UNITED STATES PATENT AND TRADEMARK OFFICE

Office Action Summary

10/519,982

DETAILED ACTION

Figure i- Applicant's figure.

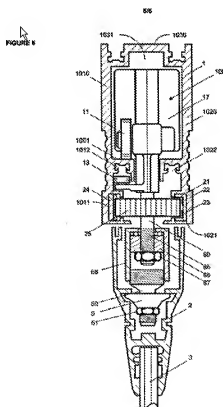
Applicant discloses the apparatus seen below:

- at least two drive assemblies which have,
 - supporting rollers guided in a guide rail,
 - the guide rail has a center piece two side pieces,
 - a drive shaft aligned at right angles to the running direction of the drive unit,
 - an electric motor in the first drive assembly connected to a drive wheel which engages a toothed element within the guide rail in the element. The axis of the motor lies between the supporting rollers and at right angles to the plane defined by the running surface of the rollers. The motor shaft is connected to the transmission via the drive shaft and they are both aligned in parallel to the axis defined above,
 - an attachment element that holds the separating element.

Krähenbühl et al. teaches running rollers in the basic structure of the apparatus (fig.1, 16) which are used to guide the apparatus along a given path. These rollers correspond to applicant's guide rollers (fig.6, 13) seen above.

Figure ii- Krahenbühl et al. reference.

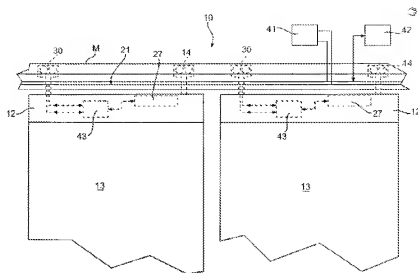
Krähenbühl et al. discloses a drive assembly in figure 5, item 14 which has connected to it a separating element (fig.1, 10) in the form of a sliding wall.

Figure iii- Krähenbühl et al. reference.

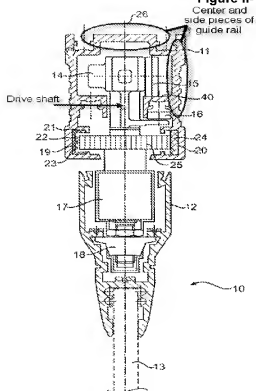
- at least 2 drive assemblies (fig.5, 14, 30),
- supporting rollers 15, and 16 which are guided in a guide rail 11 seen in figure 1,

- a guide rail having a center piece and two side pieces as depicted in figure 1 and it also provides running surfaces for the rollers.
- a drive shaft (labeled in figure 1 below) which is aligned at right angles to the running direction of the rollers,
- a drive wheel (fig.1, 25) which can be rotated via the drive shaft and said drive wheel engages a toothed element (fig. 1, 24) that is arranged within the inner wall of the guide rail. This drive wheel could be considered a transmission since it transmits torque and allows the apparatus to move laterally,
- an electric motor (fig.2, 27) located in the drive module for actuating the apparatus,
- an attachment element (fig.1, 12) which holds a separating element (fig.1, 10).

Krähenbühl et al. fails to teach the same positioning of the electric motor as the applicant. The electric motor in Krähenbühl et al. is located in a drive module (fig.1, 17) which is located beneath the rollers and running surfaces.

The housing structure shown in Krähenbühl et al. (fig.1, 11) could be considered an integral body suitable for holding the electric motor as claimed by the applicant; especially since the motor used in Finke is made to be placed within a housing structure or frame.

applicant's bus bar. By definition a bus bar is equivalent to a strip of conducting material and therefore could be considered a conducting rail. Additionally, Krähenbühl et al. teaches conductors or current collectors (fig. 1, 22, 23) which are arranged in the drive apparatus as well which corresponds to applicants current collectors.

Figure vi- Bischof's apparatus

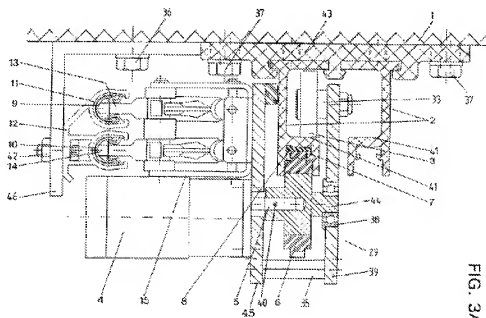
Bischof et al. teaches bus bars and current collectors (fig. 3a, 9,10,13,14) which are arranged at the upper face of the drive assembly for the purpose of taking up a small amount of space vertically and horizontally, thus simplifying

manufacturing (col. 6, lines 25-33). The location of the bus bars also helps for the maneuverability of the movable partition (col.5, lines 9-23).
